1022 Meredith Avenue - Preliminary
9/26/90 SUBDIVISION + Consultation

Re: Preliminary Consultation on Lots 10 and 11
Meredith Avenue, Silver Spring

SUBJECT: Review of Subdivision Plans

Preliminary Plan 1-89263
NAME OF PLAN: CAPITOL VIEW PARK

SITE PLAN

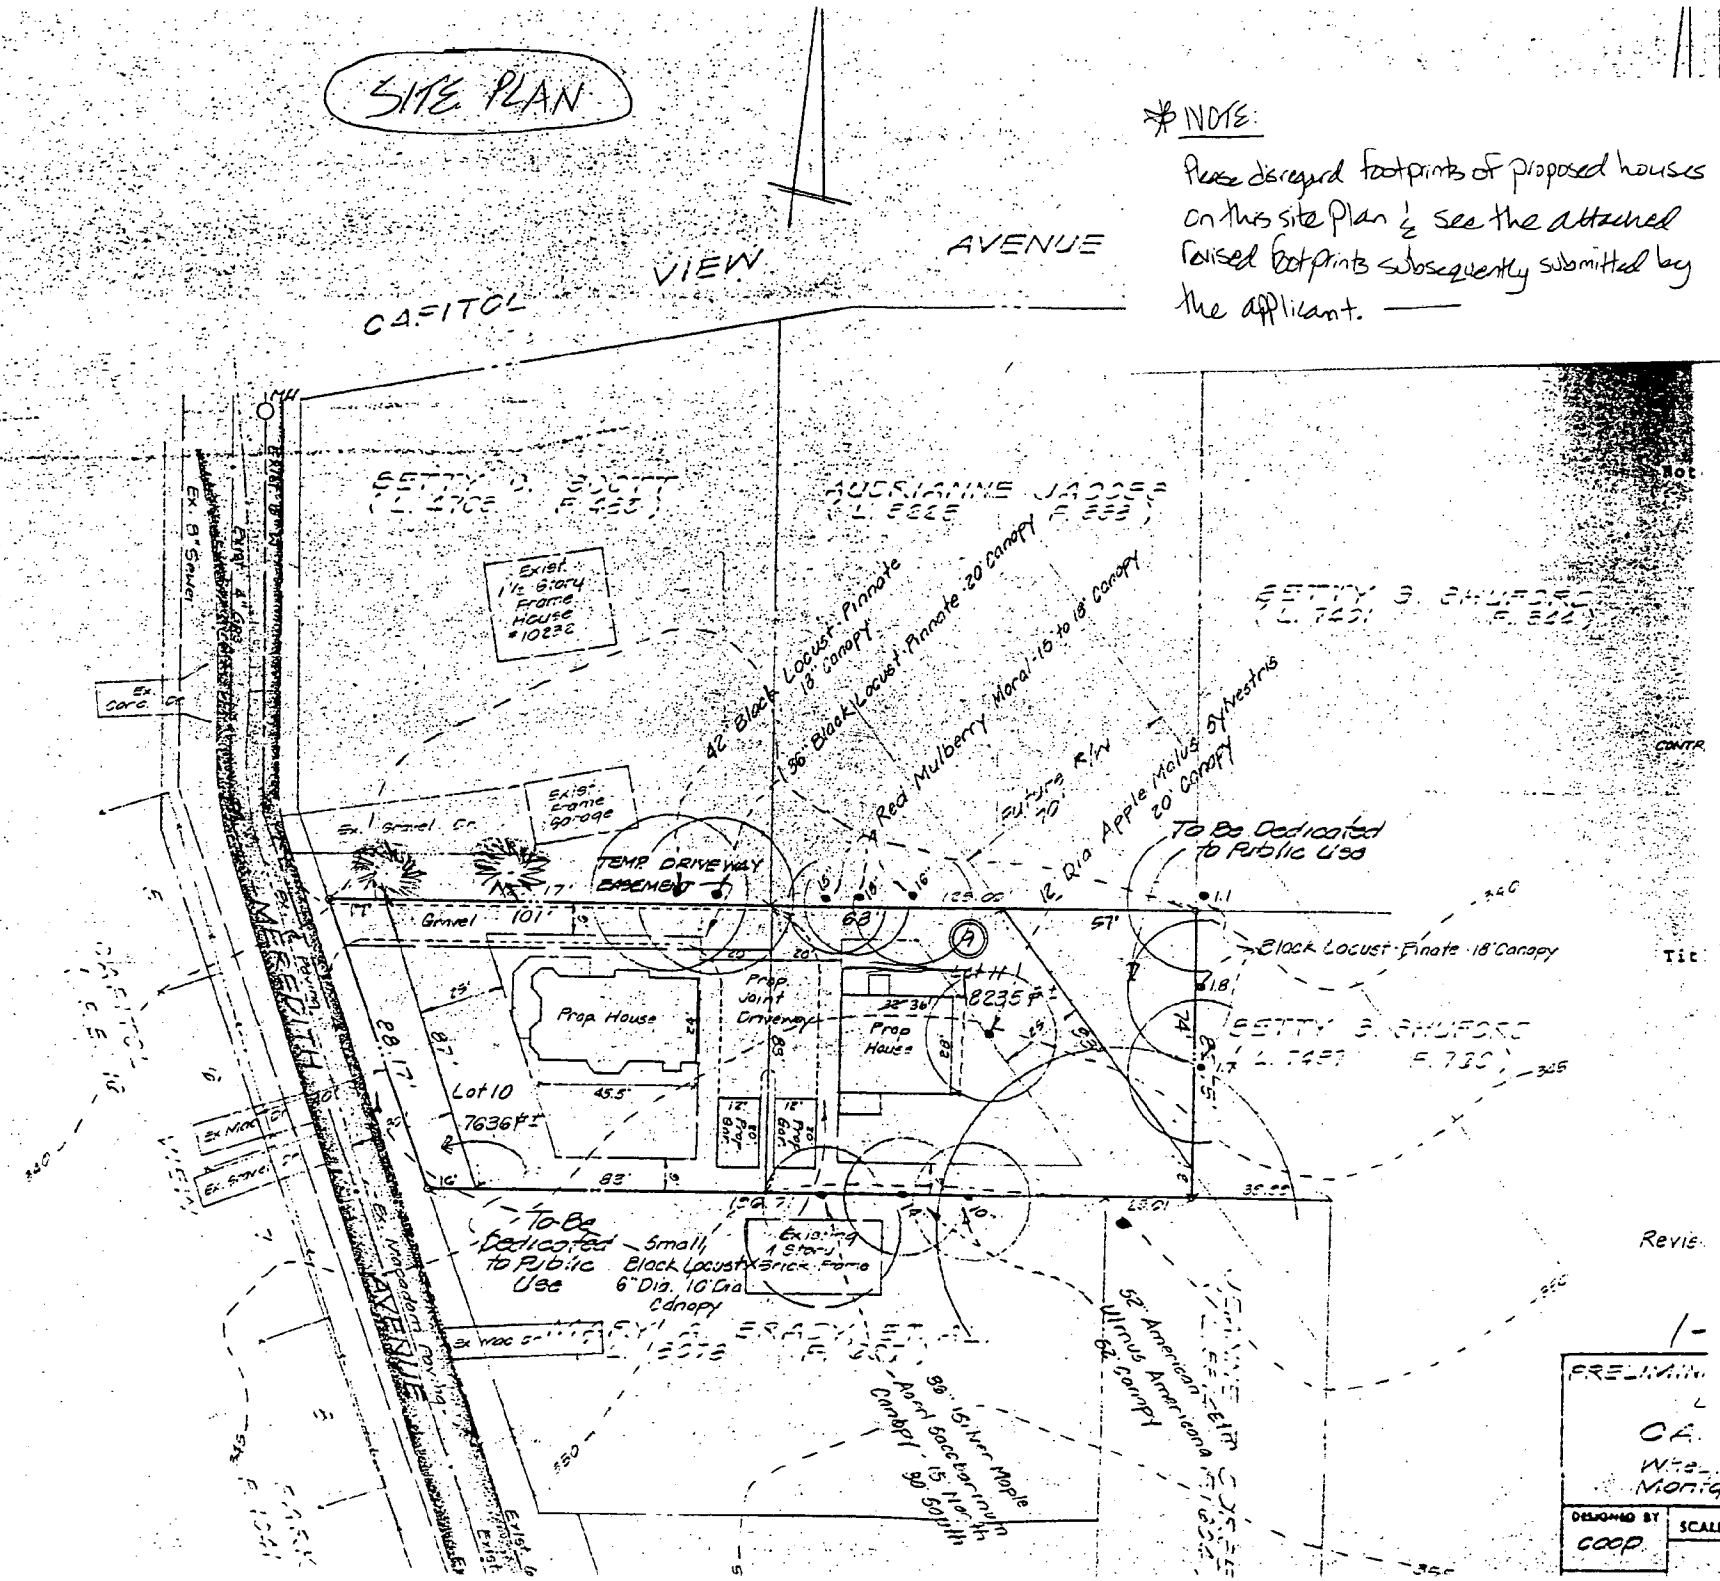
Please disregard footprints of proposed houses on this site plan & see the attached revised footprints subsequently submitted by the applicant.

LOT 11 - NORTH ELEVATION

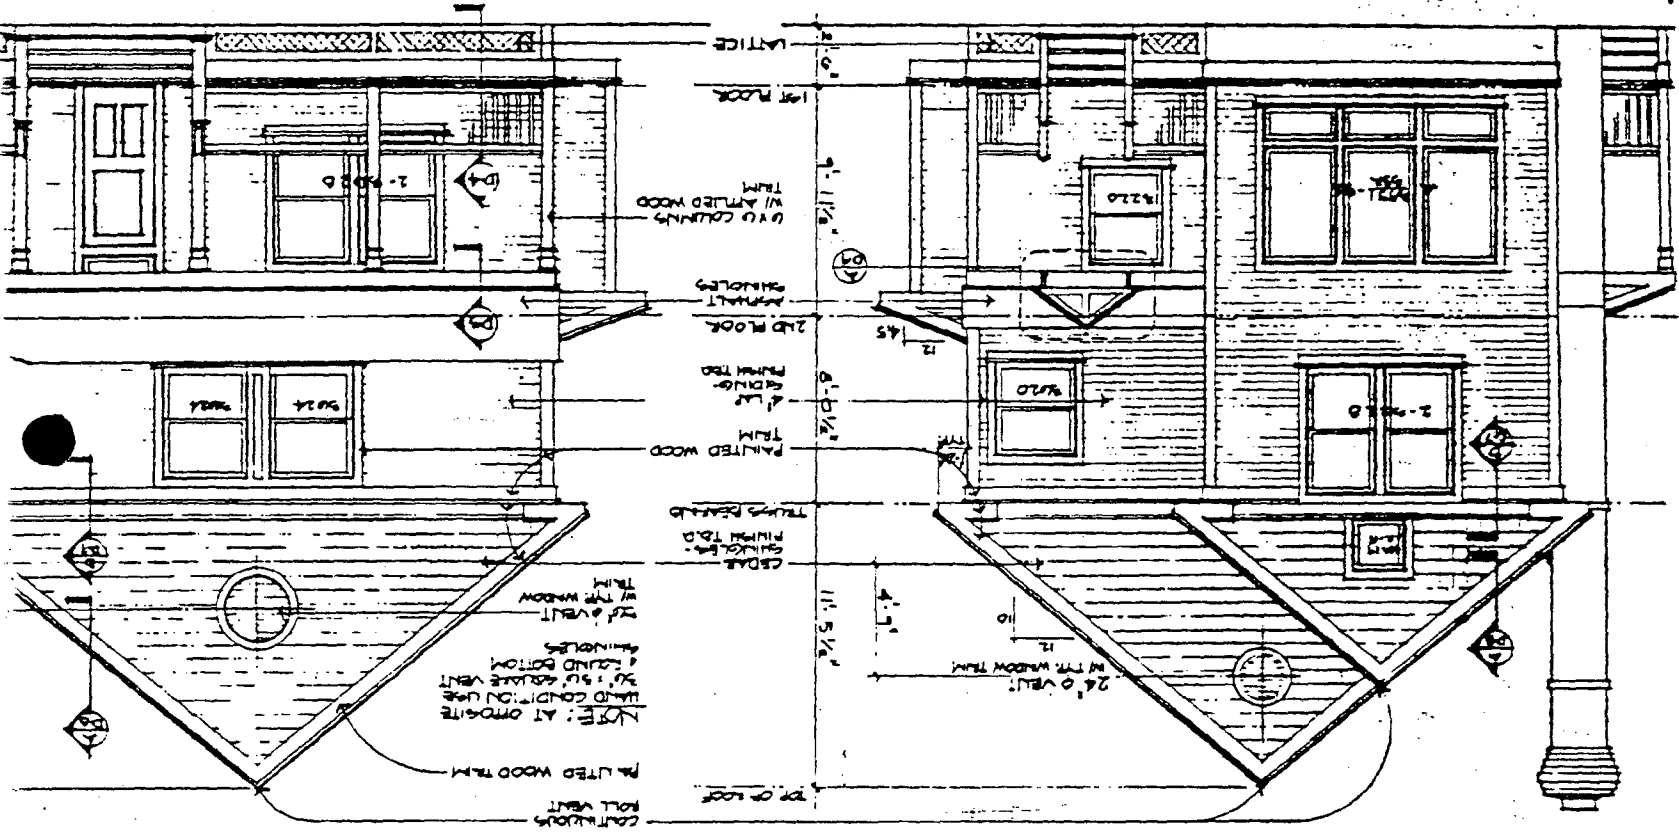
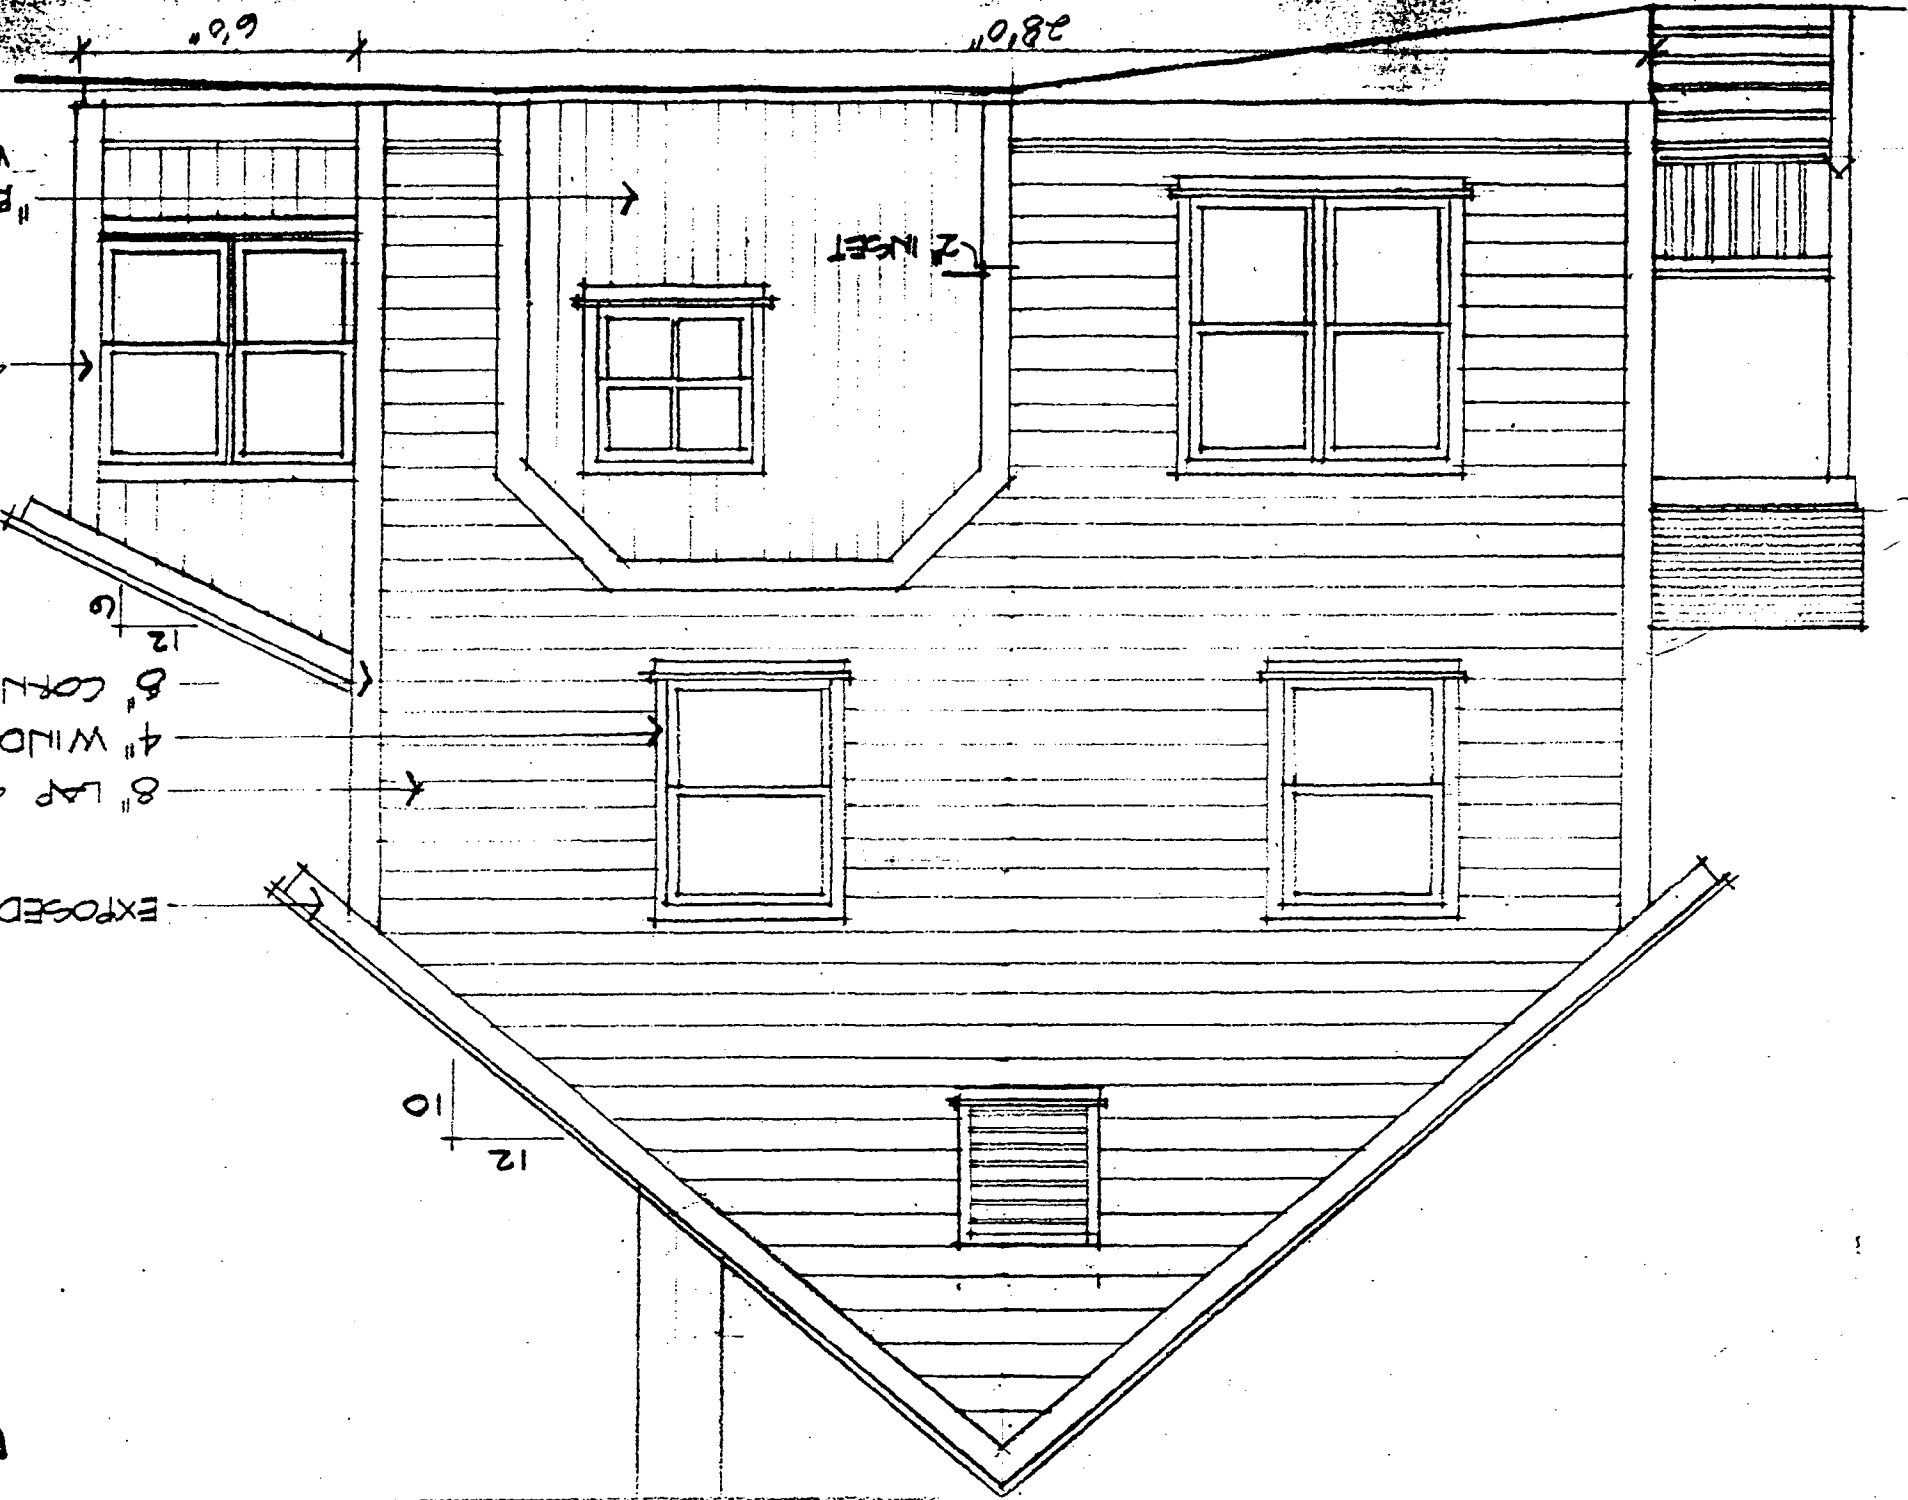
The LAP suggests that the proposed standard Neo Victorian homes proposed for lots 9 and 10 are 2 1/2 - 3 story structures in an area of 1 - 1 1/2 story bungalows, closely clustered around the proposed construction site.

In short, the LAP expresses some concern on the height, massing and overall size/footprint of the proposed construction with respect to the surrounding structures.

PRELIMINARY

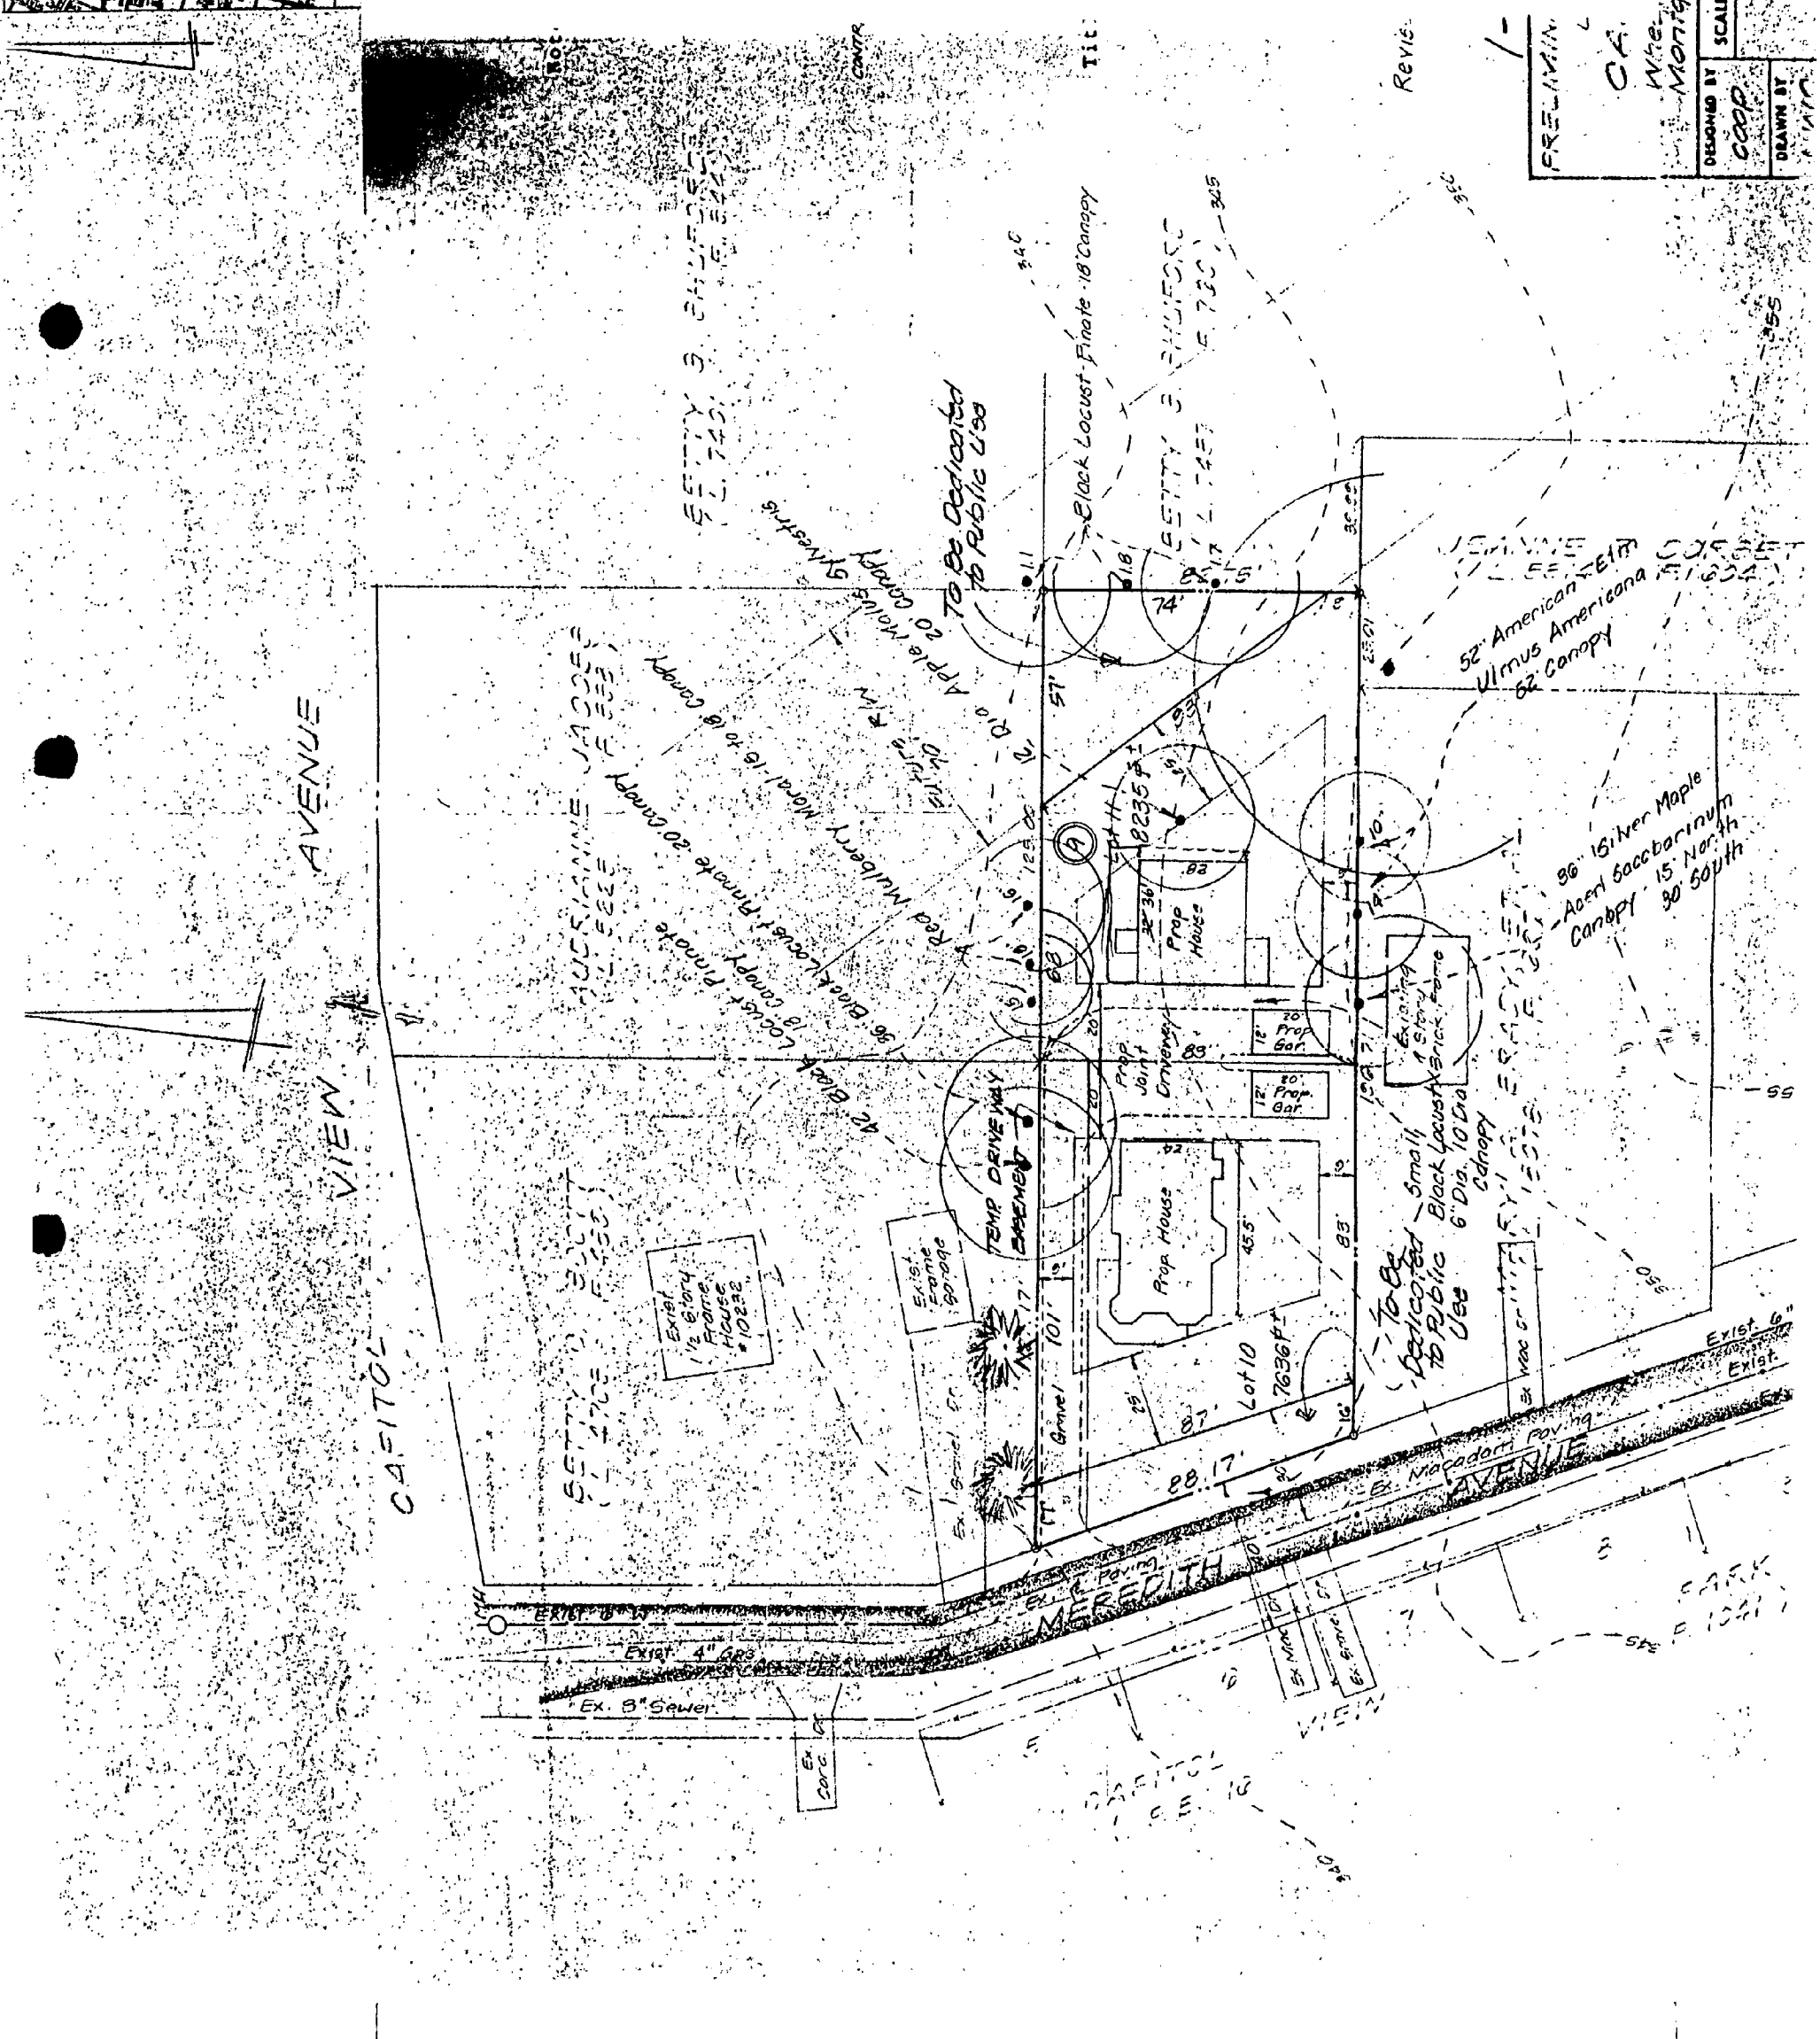
Please disregard footprints of proposed houses
on this site plan & see the attached
revised footprints subsequently submitted by
the applicant. —
